ALAMEDA COUNTY
HEALTH CARE SERVICES

October 13, 2006

Subject: Fuel Leak Case No. [REDACTED], Vic's Automotive, 245 8th Street, Oakland, CA

ALL ENVIRONMENTAL, INC.		
2641 CROW CANYON RD, SAN RAMON		
SCALE: 1 INCH = 15 FEET	APPROVED BY:	DRAWN BY: C.J.L.
DATE: 7/30/93		REVISED: C.J.L.
REVISED SAMPLE LOCATION MAP		
VIC'S AUTOMOTIVE		DRAWING NUMBER: FIGURE 3

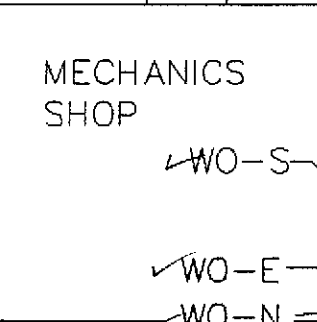
1. Soil sample EB-11' was taken from the gasoline tank pit excavation, not from the waste oil tank pit. The location of EB-11' was between the southern ends of tank A, at 11 feet depth below grade. EB-11' was not analyzed for total oil and grease as originally reported in the report text. Table 3, depicting EB-11' sample analysis, is correct.
2. The waste oil tank pit sample locations depicted on Figure 3: Sample Location Map, are mislocated by 90 degrees, or one quadrant. That is, each sample was actually taken from the adjacent wall, counter clockwise from their locations shown on Figure 3. A revised Figure 3 is attached.
